**IOWA DEPARTMENT OF NATURAL RESOURCES
ADDENDUM No. 1
LAND & WATERS BUREAU**

STATE FOREST NURSERY
RESTROOM RENOVATION
STORY COUNTY, IOWA
PROJECT NUMBER: 19-02-85-01

June 14, 2018

SUBSTITUTIONS:

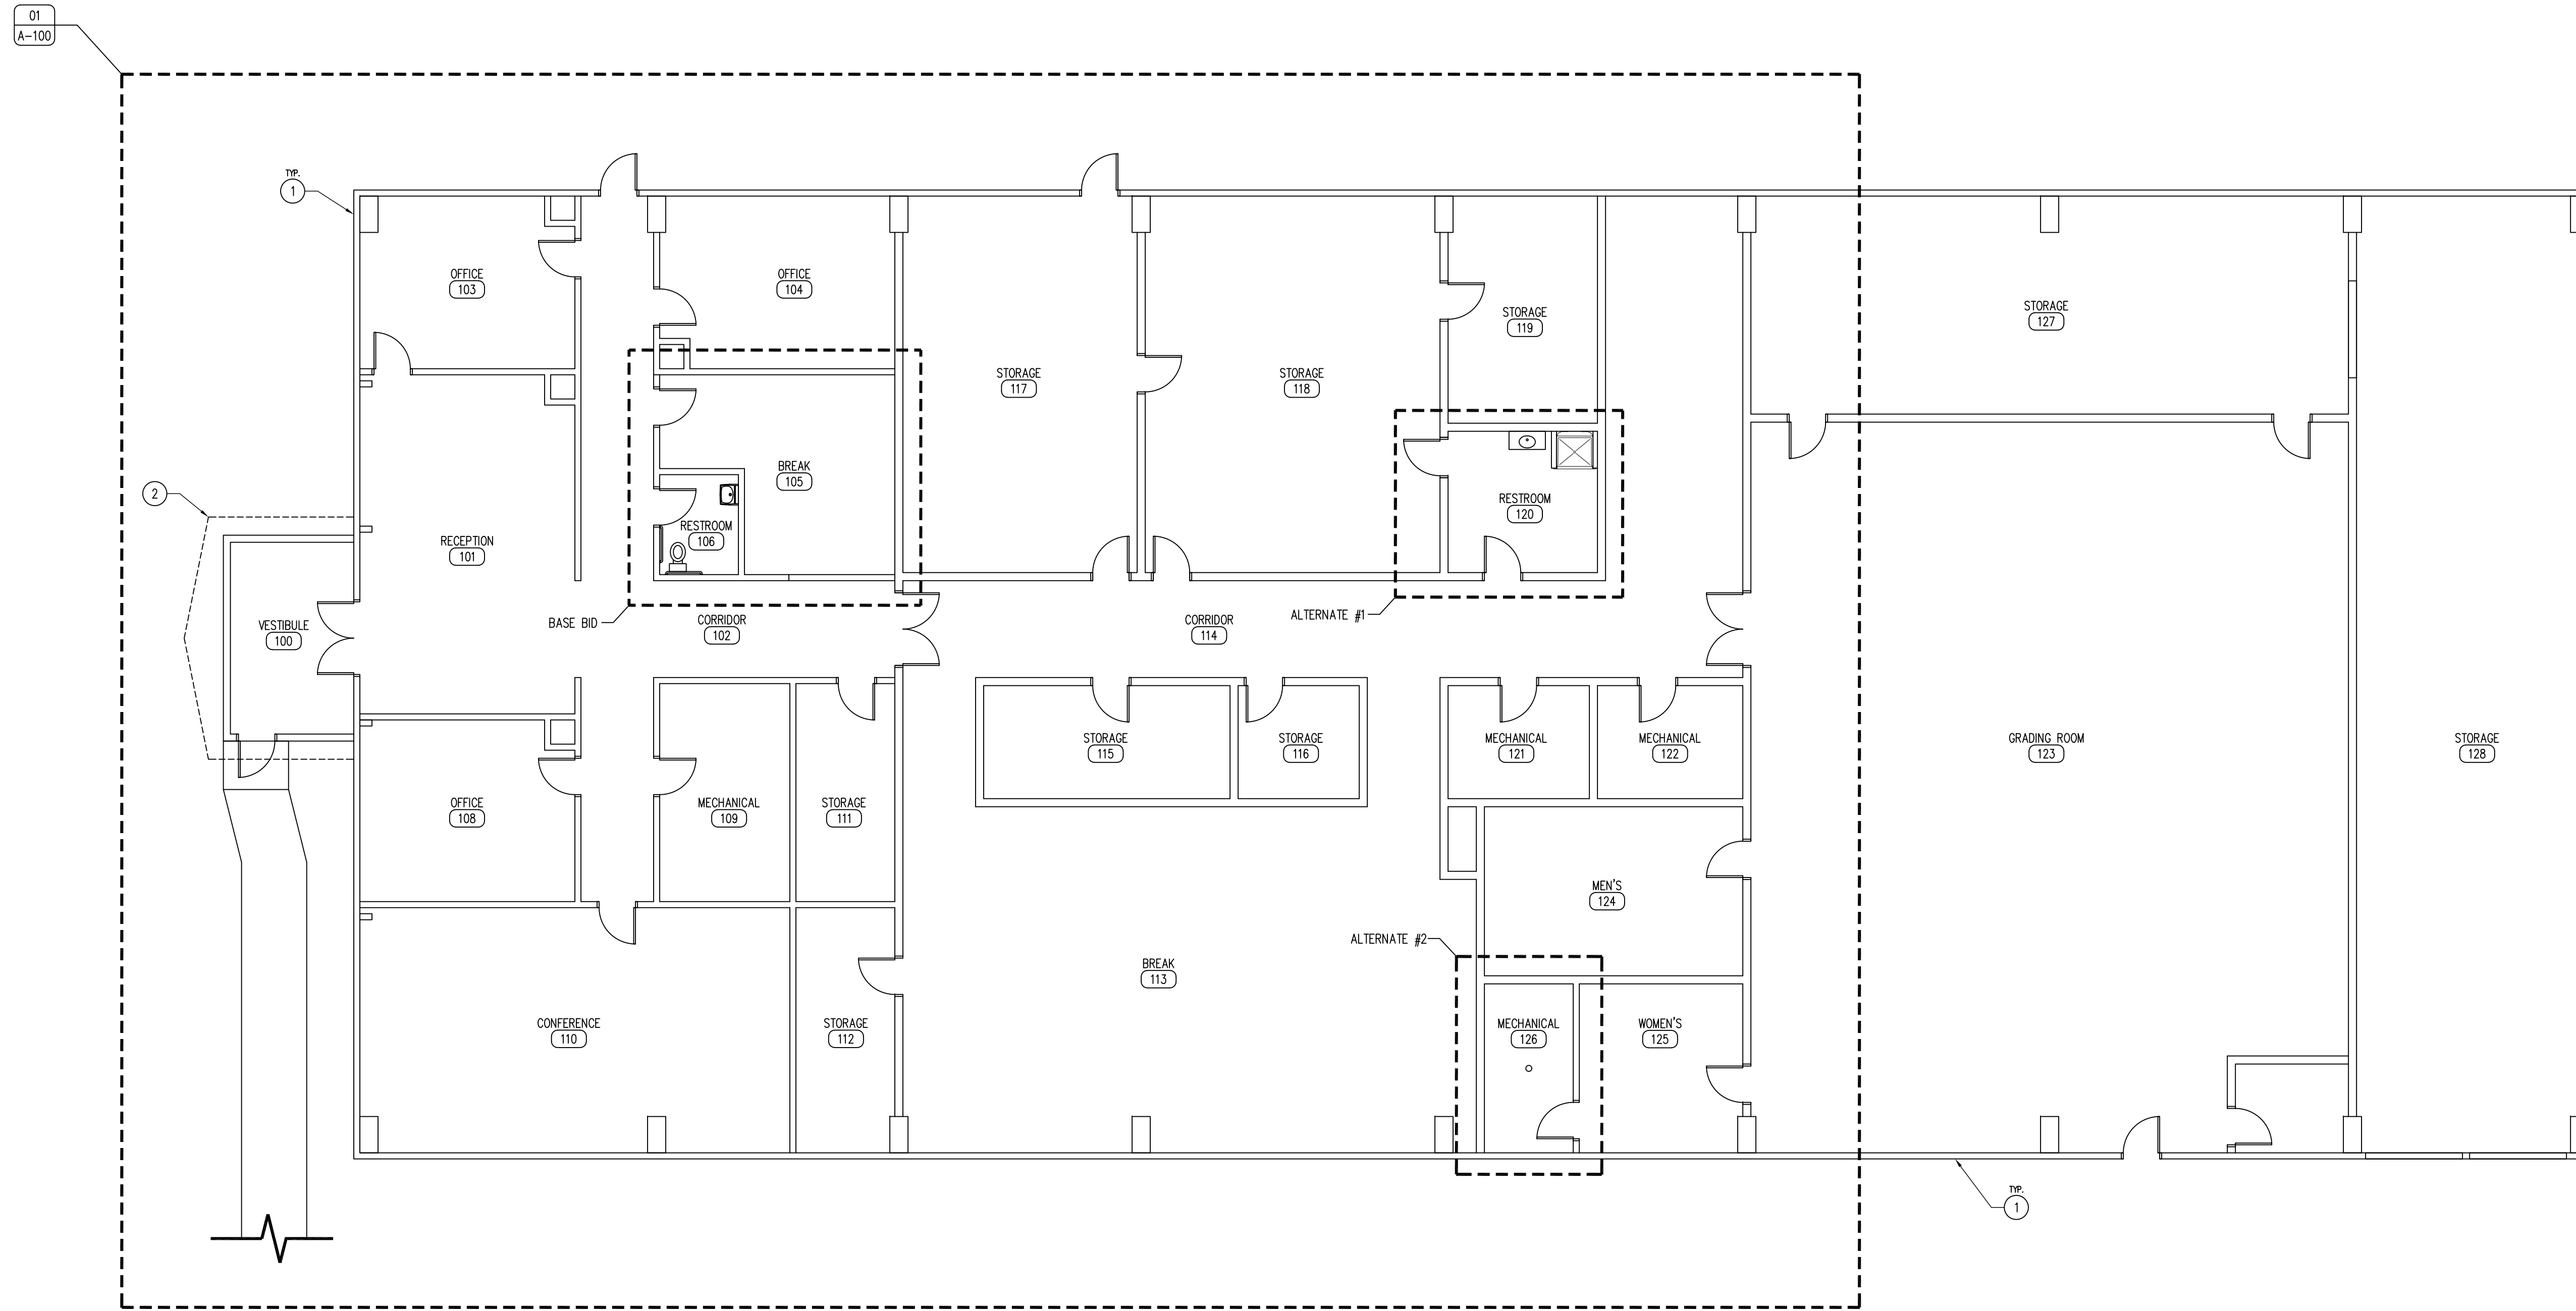
1. SANIFLOW – SPEEDFLOW PLUS (M17ACS-UL) HAND-DRYER IS AN APPROVED EQUAL TO THE SPECIFIED PRODUCT.
